CO₂/FC correction for (N)OVC-HEV/(N)OVC-FCHV

Proposed update by ACEA EV for WLTP SG EV to give the option to avoid unnecessary testing without additional value (**updated proposal**)

Status: 05.03.2020

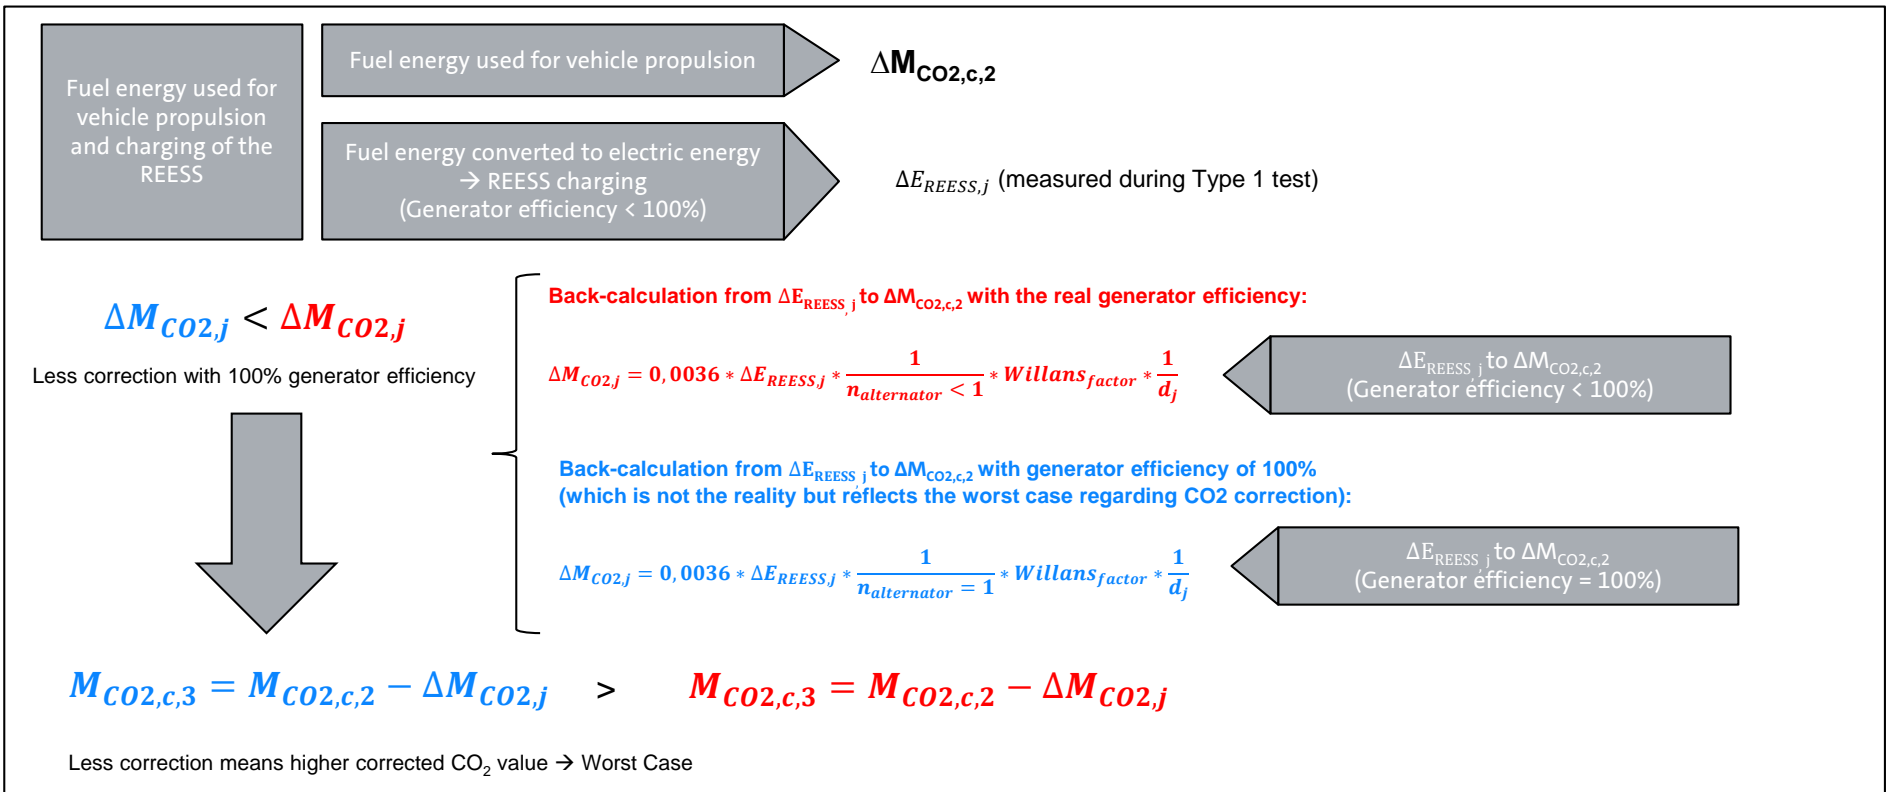
- ACEA EV is supporting the approach of a generic worst case correction as for pure ICE vehicle due to
 - the high measurement effort nowadays without any additional value (as factor are similar/identical)
 - the procedure is not reproducible due to measurement inaccuracies caused by small REESS compared to absolute CO₂ values; therefore massively different corrections could be the consequence)
- It should be at the option of the manufacturer to use a generic worst case correction or to use a physically determined K_{CO₂} factor
- Proposal: Use of the pure ICE vehicle approach but apply different generator efficiency depending in the case of REESS charging
 - Generator efficiency “n_{alternator} = 1” is “Worst case approach”

Calculation of CO₂-Delta which need to be corrected:

$$\Delta M_{CO_2,j} = 0,0036 \times \Delta E_{REESS,j} \times \frac{1}{\eta_{alternator}} \times Willans_{factor} \times \frac{1}{d_j}$$

→ With n_{alternator} = 1 → smallest ΔM_{CO₂,j}

Calculation of corrected CO₂ value:

$$M_{CO_2,e,3} = M_{CO_2,e,2} - \Delta M_{CO_2,j}$$

→ With smallest ΔM_{CO₂,j} → highest M_{CO₂,e,3}
